**Subject: MicroCoin Cable Routing**

**Overview**

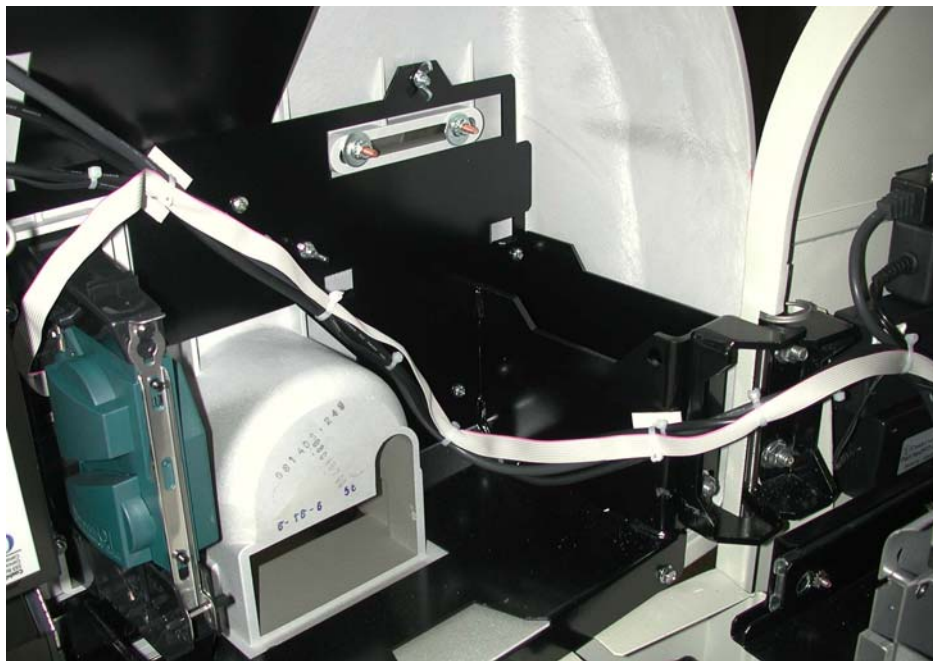
There have been reports of the ribbon data cable from the MicroCoin Coin Dispenser getting frayed and/or damaged by repeated opening and closing of the cabinet door. This has been attributed to inconsistent routing and securing of the cable during production.

On a next visit basis, ensure the cables are routed and secured properly to prevent excess wear when the door is opened. Using approximately 7 tie-wraps, secure the data cable as illustrated below. The ribbon cable needs to be kept clear of the hinge area and the coin dispenser as the door opens and closes

All systems are now being shipped with 3/4" wire loom. The assembly instructions have been modified to include a protective wire loom, correctly placed tie-wraps and to ensure consistency in cable routing. See illustration below of new wiring loom and routing.
